Modified Water Deliveries to Everglades  
National Park  
8.5 Square Mile Area

Volume 1  
GRR/SEIS  
Comment Letters Received  
5/30/00

Modified Water Deliveries to Everglades National Park  
8.5 Square Mile Area  
Table of Contents

# Figure A-1 Selected Indicator Cells

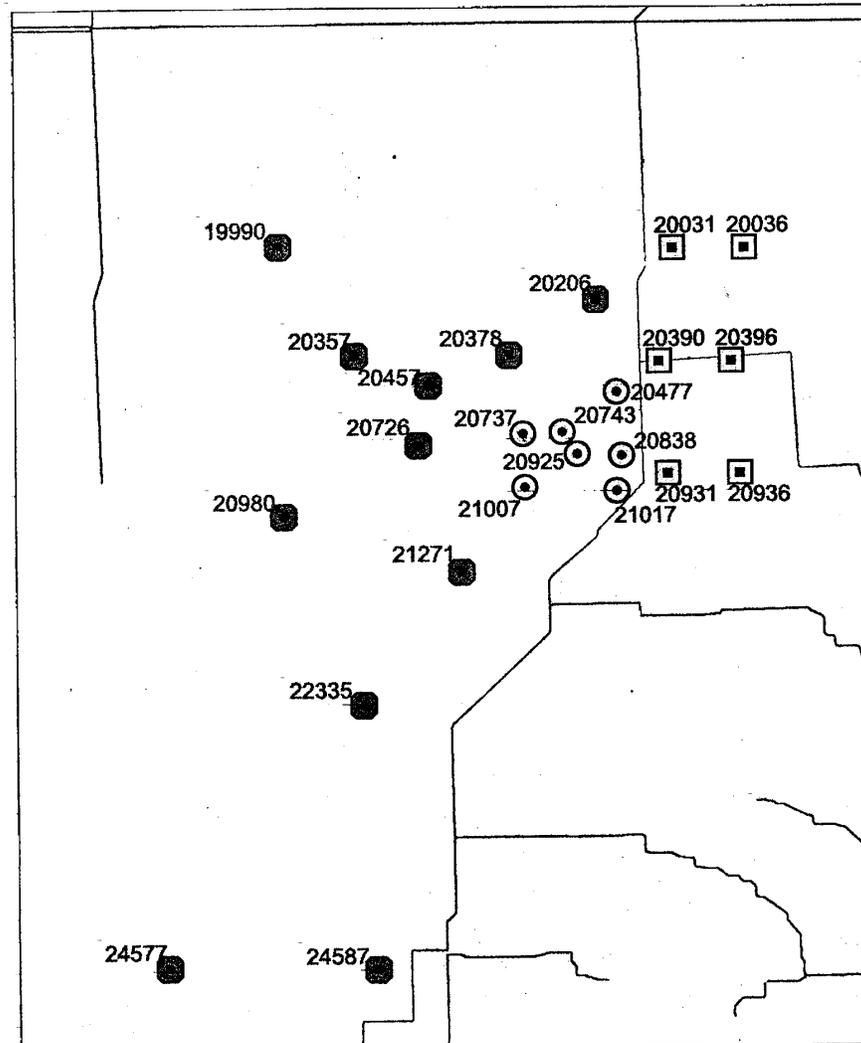
Each project requirement is provided with a separate section. Stage hydrographs for selected indicator cells (see also Figure A-1) were reviewed and evaluated according to guidance provided in the GRR/SEIS. General observations and conclusions are described for each modeled alternative. For each modeled alternative, a more detailed description of observations is provided in tabular format.

### 1.3.5 Evaluation of Alternatives 6c and 6b

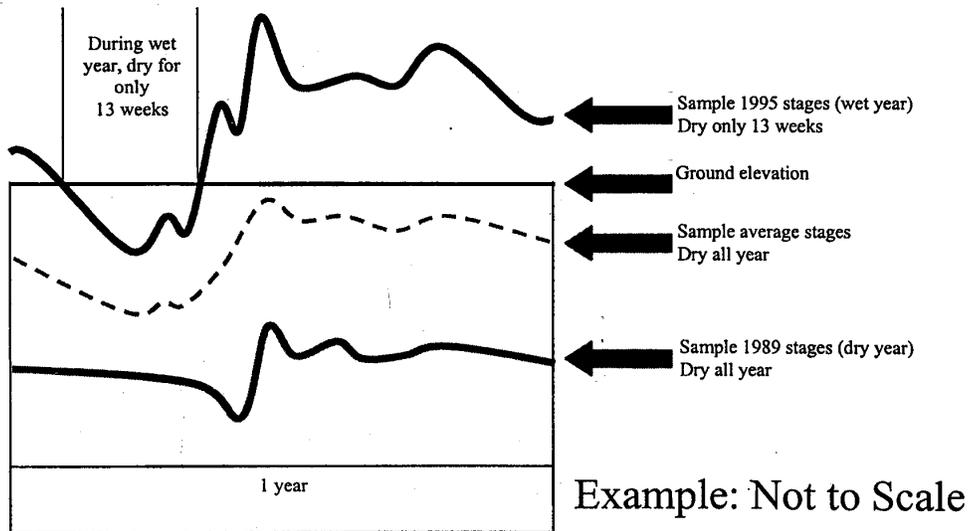
In response to various government agency and public comments, the USACE conducted modeling of additional Alternatives during May 2000. The new Alternatives are identified as Alternative 6c and Alternative 6d. Resulting supplements to the draft GRR/SEIS were posted to the internet (<http://www.saj.usace.army.mil/dp/mwdc111-1.htm>) by the USACE during mid-May. The revised and updated materials included an addendum to the GRR/SEIS and an updated version of the Draft Coordination Act Report generated by the United States Fish and Wildlife Service and National Park Service. We recognize and respect the fact that project managers and staff are attempting to adhere to a strict project timeline in an effort to rehydrate ENP as soon as possible. However, these new materials were released for public review approximately 15 days prior to the close of public comment. Furthermore, information presented in the addendum for Alternatives 6c and 6d did not include the array of information presented for the other Alternatives (i.e.: indicator cell data and hydrographs). As a result, our comments on the hydrological performance of Alternatives 6c and 6d are brief. Likewise, we will (if needed) provide additional comments on new materials as they are generated.

For the purposes of evaluating Alternatives 6c and 6d, various materials were reviewed. Materials included documents and reports presented at public meetings/workshops held since the release of the Draft GRR/SEIS, and information presented in the updated GRR/SEIS documents. The following pages include discussion of our evaluation, observations, and findings.

Average Monthly Overland Flows South of Tamiami Trail East of L-67ext. to ENP for the 31 yr. simulation

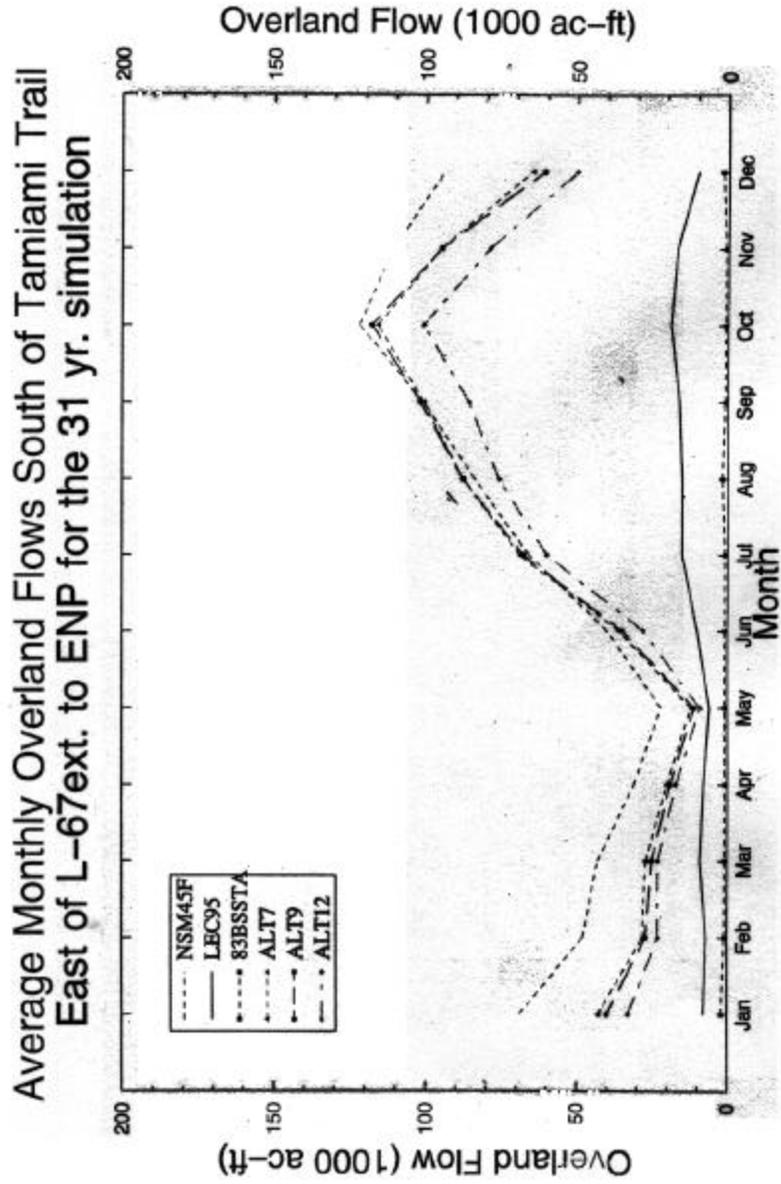
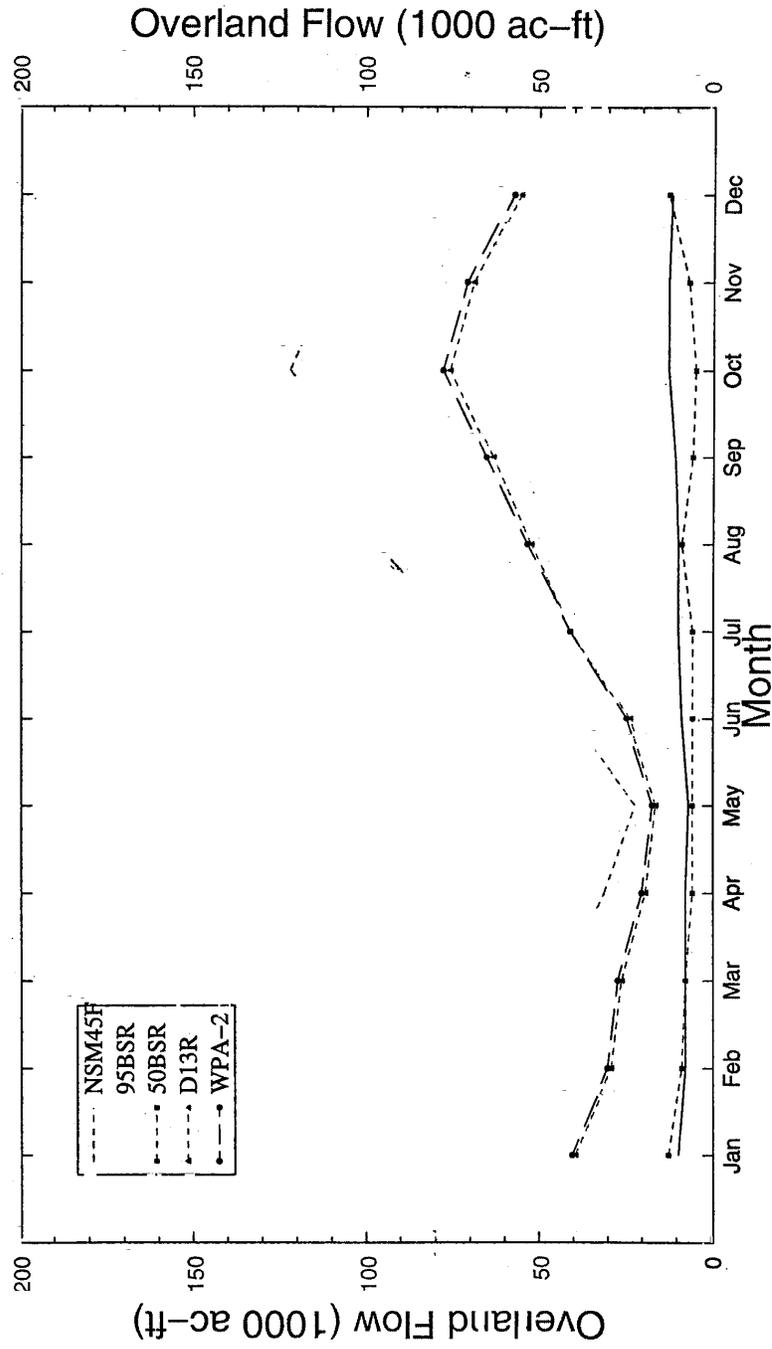
Model results posted onto the Internet by the South Florida Water Management District<sup>20</sup>, show different values for average monthly overland flows just south of the Tamiami Trail. For months July through November, the Modified Water Deliveries project regional conveyance modeling predicts average monthly flows to be approximately 20,000 to 50,000 acre-feet greater than those anticipated under D13R conditions (conditions used for the 8.5 SMA Alternative modeling).

We encourage the USACE to evaluate the impacts of these differences and to merge the Modified Water Deliveries project regional conveyance and 8.5 SMA alternative evaluation processes into one process as soon as possible.

# Figure B-1 Existing Structure Evaluation

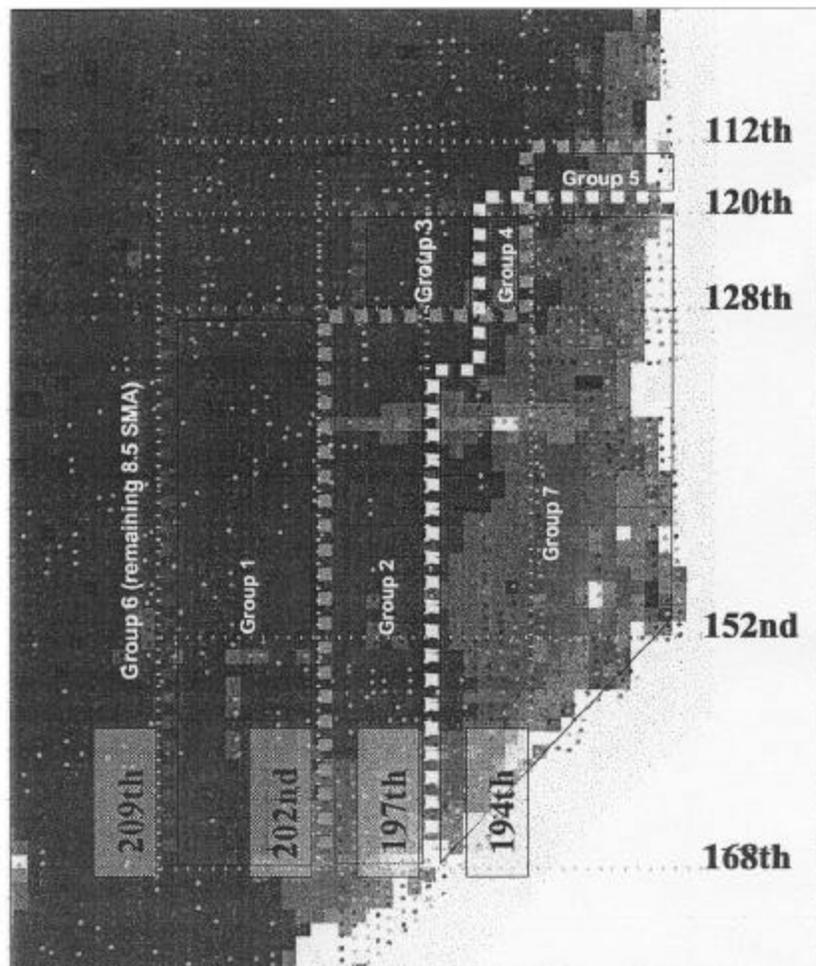
Constructing the levee at the easternmost location and highest elevation (7.2 NGVD) will result in the greatest amount of feasibility to operate the system in order to gain maximum benefits to wetlands in Everglades National Park. Constructing the levee at this elevation will impact homes and other structures within Groups 1, 2, 3, 5 and 6 whose boundaries are denoted above. The total number of homes to be impacted is 124, and the total number of trailers to be impacted is 64. Of these 188 possible living structures, only 58 are registered as legally permitted homes within the Department of Environmental Resource Management's information databases.

Constructing the levee at the midpoint elevation [7.0 NGVD (current 6B configuration)] will result in impacts to homes and other structures within Groups 1, 3, 4 and 6. Within these groups there are 84 houses and 41 trailers. Of these 125 possible living structures, only 45 are registered as legally permitted homes within the Department of Environmental Resource Management's information databases.
